| Project                      | IEEE 802.16 Broadband Wireless Access Working Group < <a href="http://ieee802.org/16">http://ieee802.org/16</a> >  |  |
| Title                        | A method which can Improve Capacity of WirelessMAN-CX  |  |
| Re:                          | IEEE 802.16 Working Group Letter Ballot #24, on P802.16h/D1  |  |

Figure 1 one example of multiple working channels

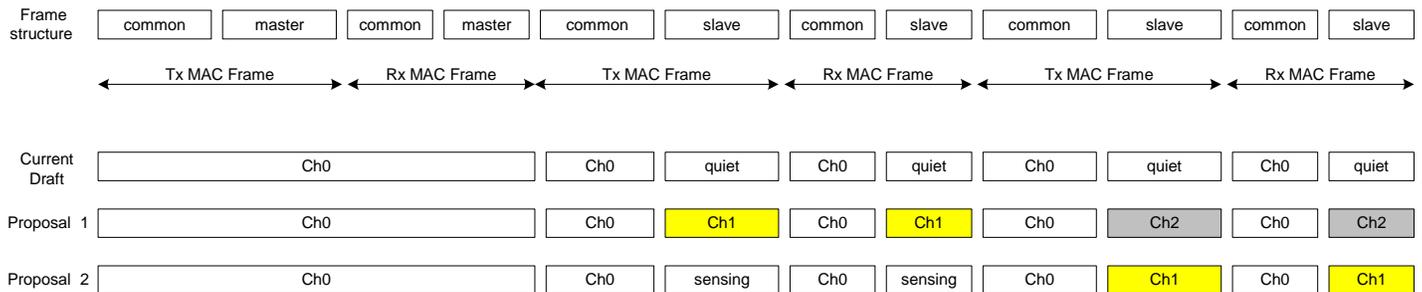
Since the slave sub-frame is periodic and long enough, so we suggest that during slave sub-frame, system may switch to another channel that may be free for this BS. Because the slave sub-frame is periodic and long enough, BS which works in slave channel is also periodic and then everything can be done during this period, including SS registration and data transmission. Following figure gives an example for type 2 sub-frame with N=3.

Since BS works at all time, the capacity of system is improved. And another benefit of this scheme is the probability of blind area is decreased since every BS may work independently in more than one channel.
